Access Compliance Report Public Rights-of-Way (Curb Ramps)

Intersection ID: N/A Main Street: CLARKSON_ST Cross Street: DUNBAR_ST Location: E

ADA ID: 0B5346F09E45 Ramp Type: Perp Initial Pass/Fail: Fail Overall Compliance: No Severity Score: 8.75

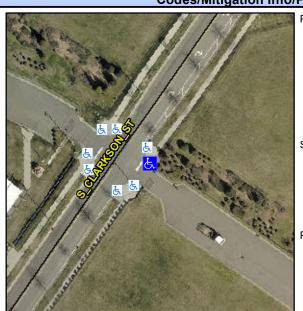
Field Measurements/Component Compnance					
Compliance Description I			Compliance Description		Data
N/A	Ramp Length (in)	94.0	Yes	Ramp Slope (%)	7.8
No	Ramp Width (in)	46.0	Yes	Ramp XSlope (%)	1.4
N/A	Flare Type LT	N/A	N/A	Flare Type RT	N/A
N/A	Flare Slope LT (%)	N/A	N/A	Flare Slope RT (%)	N/A
N/A	Flare Traversable LT?	N/A	N/A	Flare Traversable RT?	N/A
N/A	Landing Length (in)	N/A	N/A	DWS Provided?	N/A
N/A	Landing Width (in)	N/A	N/A	DWS Contrast?	N/A
N/A	Landing Slope (%)	N/A	N/A	DWS Length (in)	N/A
N/A	Landing X Slope (%)	N/A	N/A	DWS Full Width?	N/A
N/A	Landing Curb? (Y/N)	N/A	N/A	DWS Offset (in)	N/A
N/A	Shared Landing?	N/A			
N/A	Gutter Ponding?	N/A	N/A	Gutter Slope (%)	N/A
N/A	Gutter Lip Ht (in)	N/A	N/A	Gutter X Slope (%)	N/A
N/A	Painted X Walk1?	No	N/A	Painted X Walk2?	N/A
	X Walk 1 Direction	To SW		X Walk 2 Direction	N/A
N/A	X Walk 1 Width (in)	N/A	N/A	X Walk 2 Width (in)	N/A
	X Walk 1 Slope (%)	0.3		X Walk 2 Slope (%)	N/A

X Walk 1 X Slope (%)	3.1		X Walk 2 X Slope (%)	N/A
N/A	Ramp inside XWalk1?	N/A	N/A	Ramp inside XWalk2?	N/A
	Road Slope (%)	N/A	N/A	Clear Space?	N/A
	Road X Slope (%)	N/A	N/A	Clear Space to XWalk (in)	N/A
N/A	Any Obstructions?	N/A	N/A	Storm Grate/Utility Hazard?	N/A
	Obstruction Type		l	Storm Grate/Utility Type	
		N/A			N/A
			Yes	Surface Condition? (G/P)	Good
	A CONTRACT OF THE PARTY OF THE
